**FEDERAL AVIATION ADMINISTRATION
AIRWORTHINESS DIRECTIVES
SMALL AIRCRAFT, ROTORCRAFT, GLIDERS,
BALLOONS, & AIRSHIPS**

BIWEEKLY 2011-01

Emergency airworthiness directive (AD) 2011-01-53 supersedes AD 2011-01-51, issued December 18, 2010, which was sent previously to all known U.S. owners/operators of PIAGGIO AERO INDUSTRIES S.p.A (Piaggio) Model PIAGGIO P-180 airplanes.

Figure 1. Additional drain holes on keel beam webs

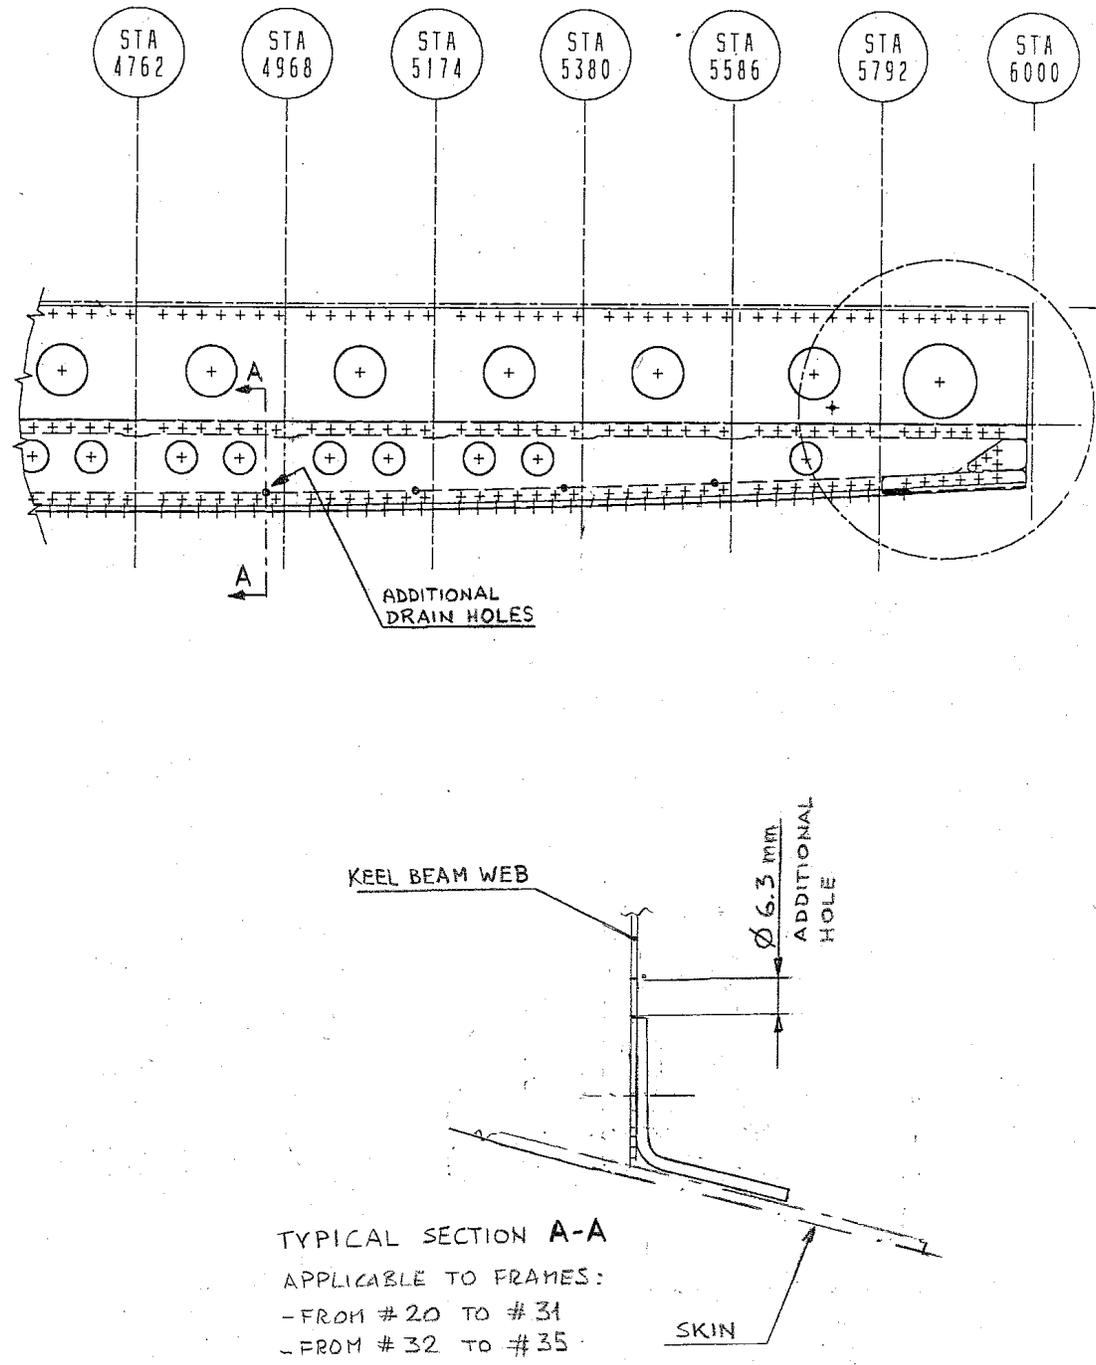
- ii. If water is found in excess of item above (4-c-i), do step 5.
5. Add 6.3 mm draining holes as per attached figure 1 (additional drain holes on keel beam webs) connecting the lateral bays to the center ones or, as alternative, apply Piaggio Aero Industries Service Bulletin 80-0291. Then proceed with step 6.

Figure 2. Fuselage Drain Holes

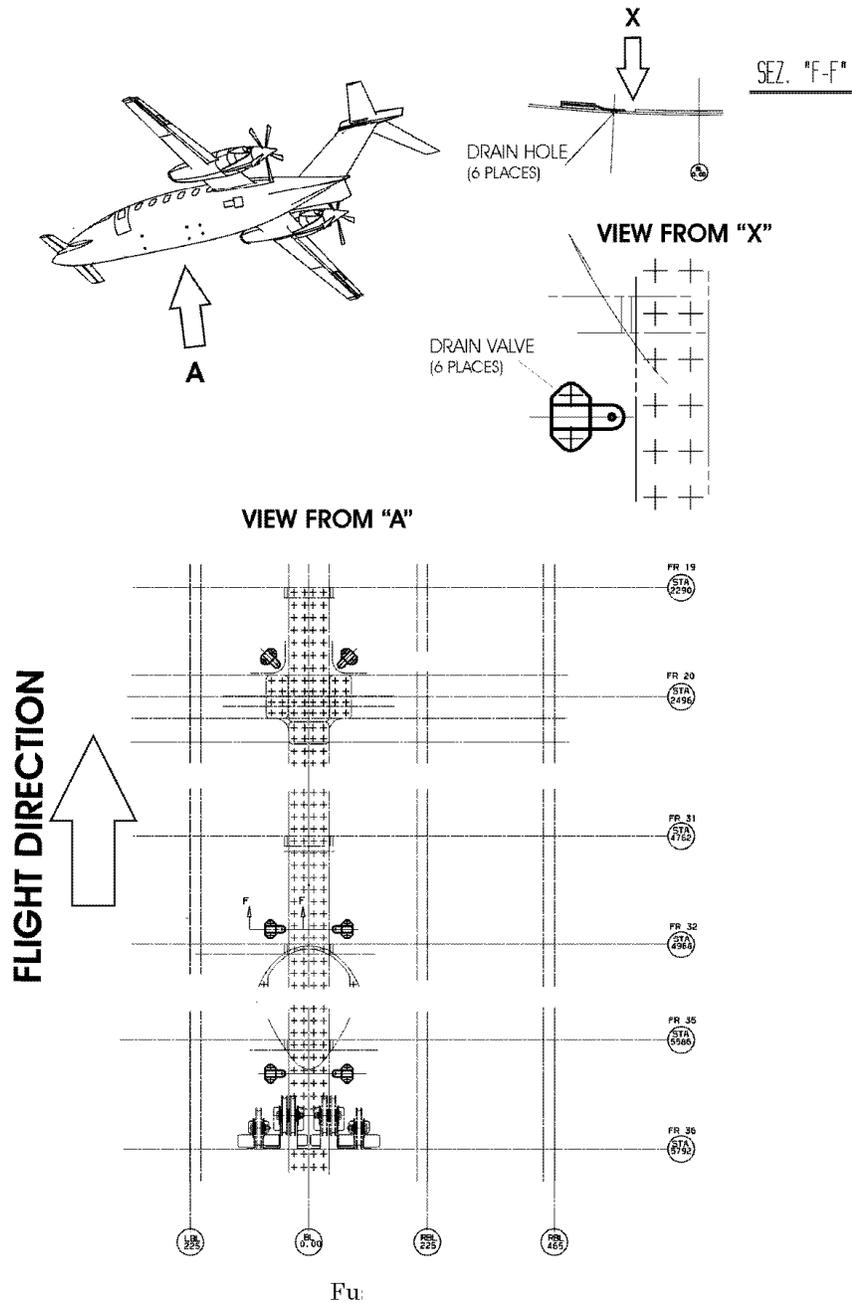
a. Place an adequate amount of water in each bay between FR 19 and FR 36 (See figure 2) to verify that the water is conveyed in the central bays and that it is drained. Use at least ½ gallon (approximately 2 liters).

b. A steady stream of water should be observed coming from the external drain holes. If not, the flapper valve does not drain properly. Cut off the rubber flap and replace the flapper valve at next A check. Take note of any cut rubber flap and its position.
